## CITY OF TONTITOWN PLANNING OFFICE

Meeting: **September 28, 2021**  
Project: **WM Container Shop**  
Planner: Courtney McNair,  
Garver

### PRELIMINARY LARGE SCALE DEVELOPMENT REQUEST

**SUMMARY:** Request to construct a 1,904 SF shop building in order to repair trash containers at the existing WM Hauling Company site.

LANDSCAPE PLAN  
WASTE MANAGEMENT  
SPRINGDALE, AR

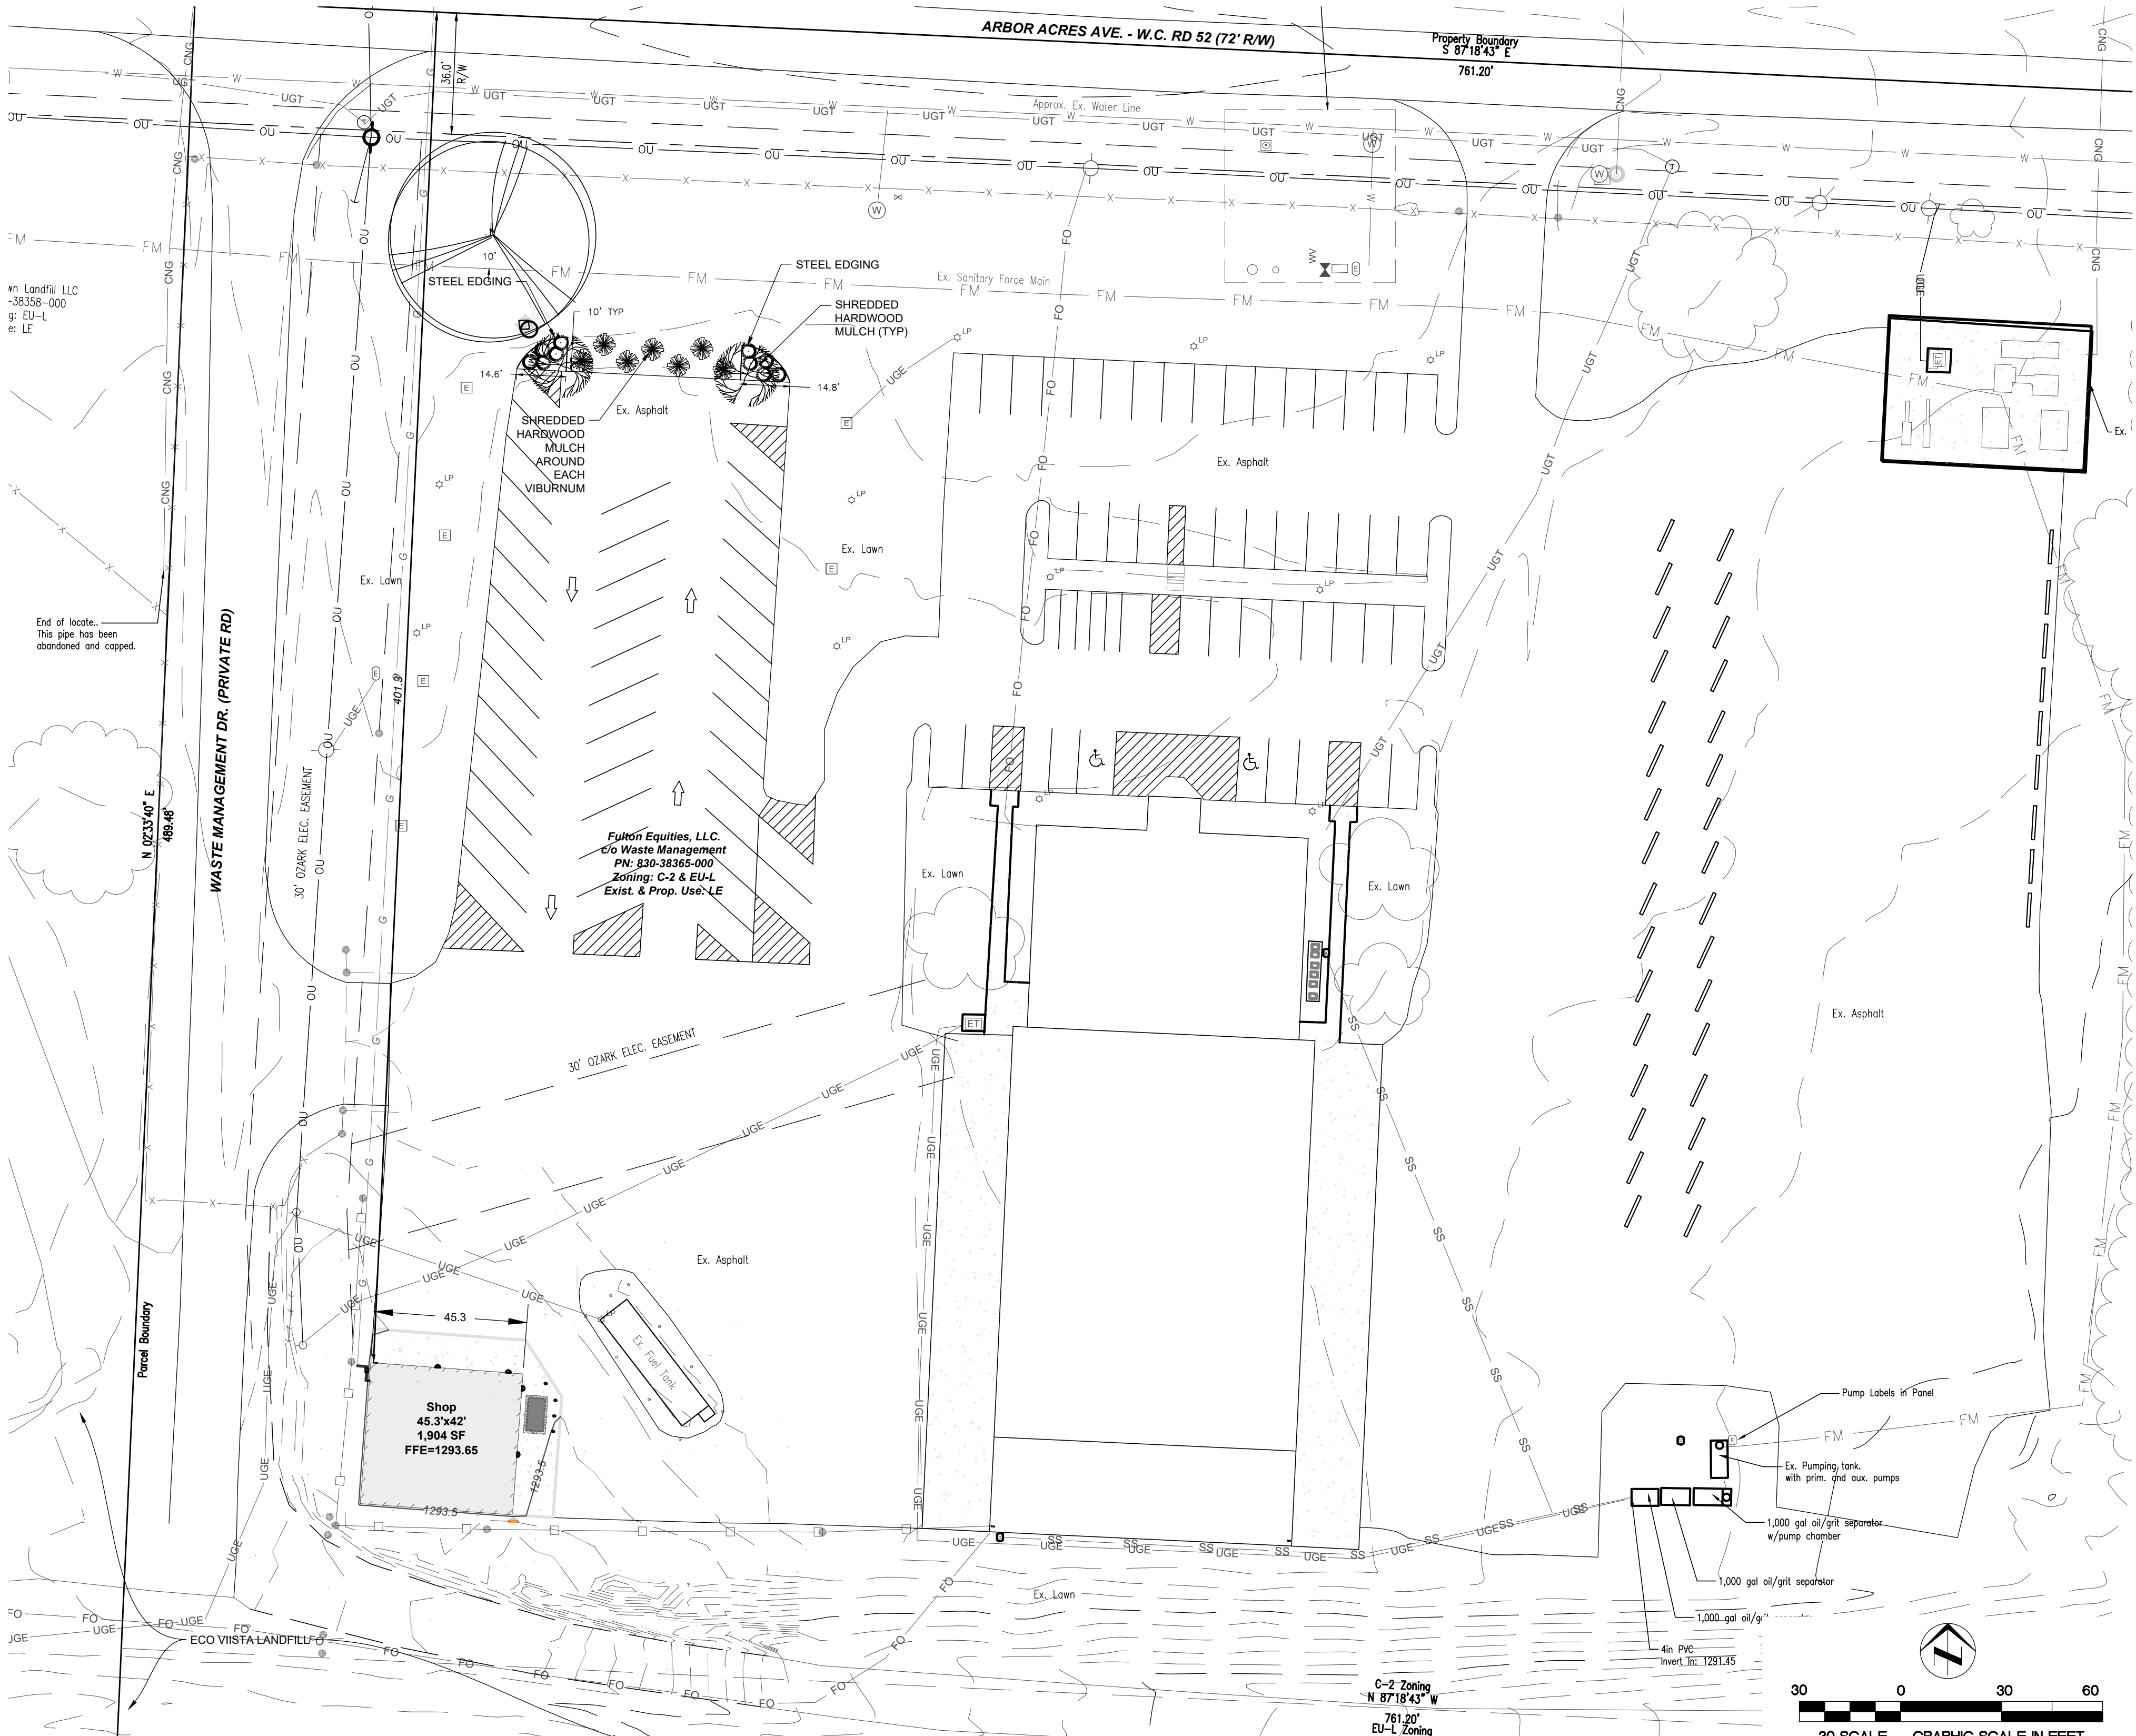
The Landscaping Plan has been submitted and provides all required landscaping as well as additional landscape screening required for the mechanical equipment.

SHEET NO:  
**A3.0**  
JOB NO:  
ENG-1571

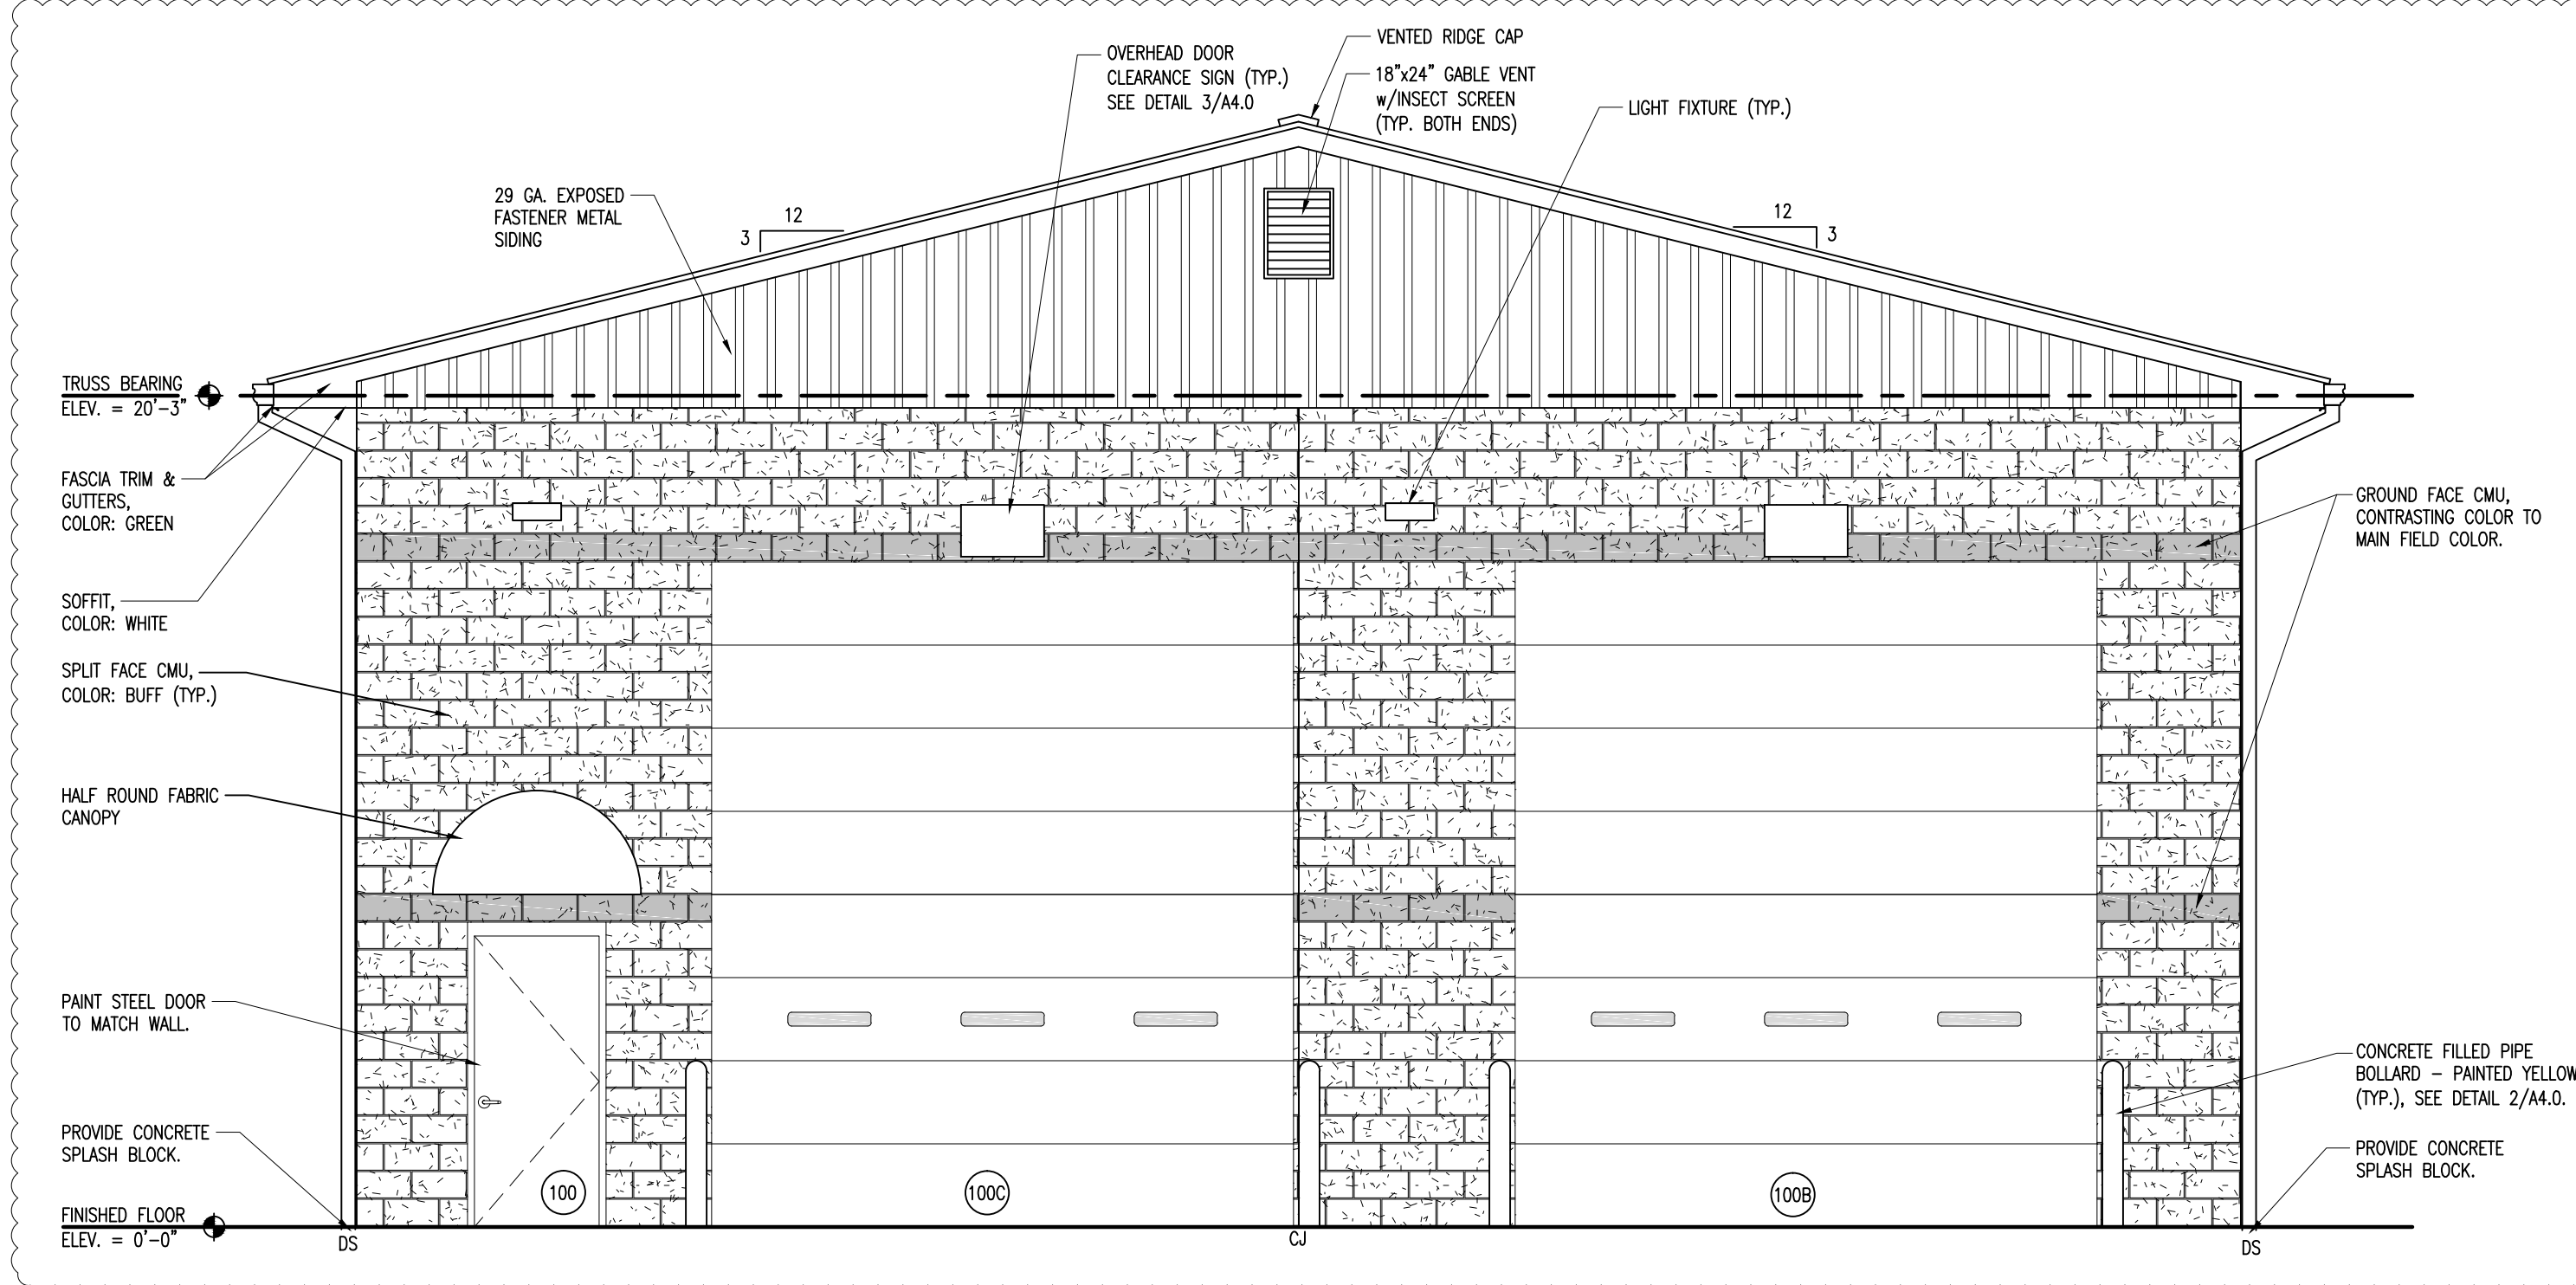
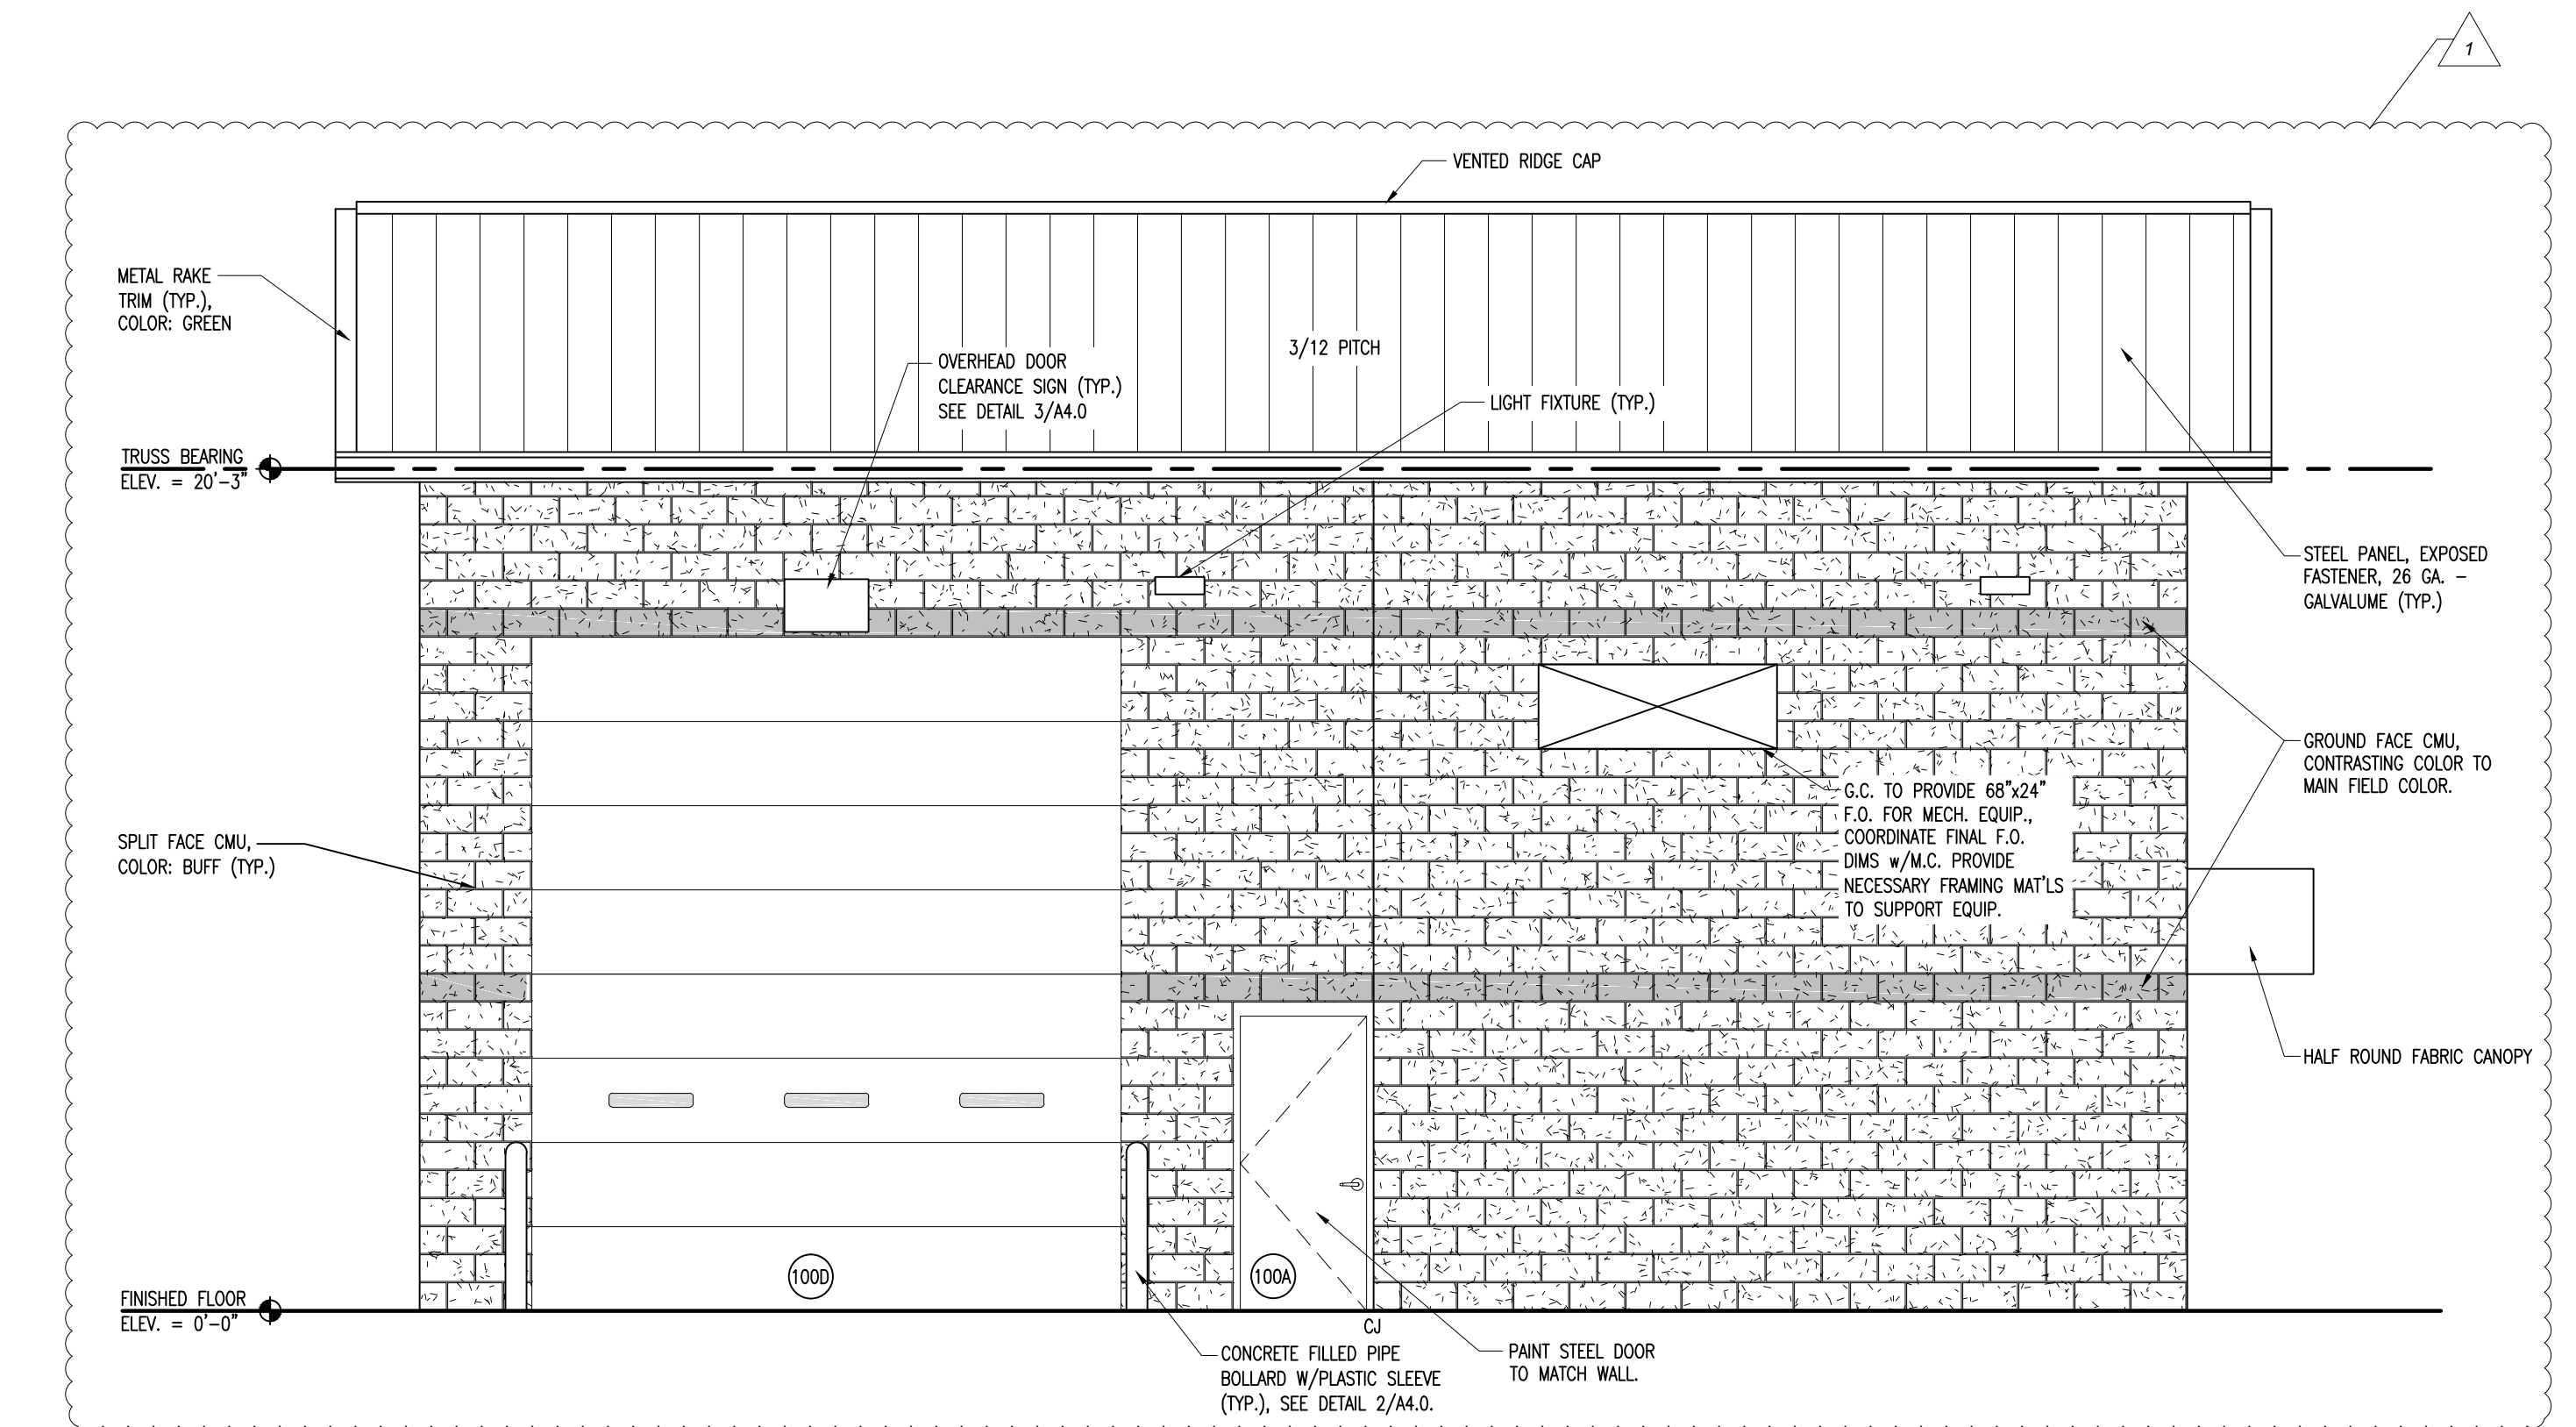
The applicant has submitted architectural elevations, and the building is in compliance with the requirements for the façade. The lighting cut sheet and photometric plan have been submitted and are adequate.
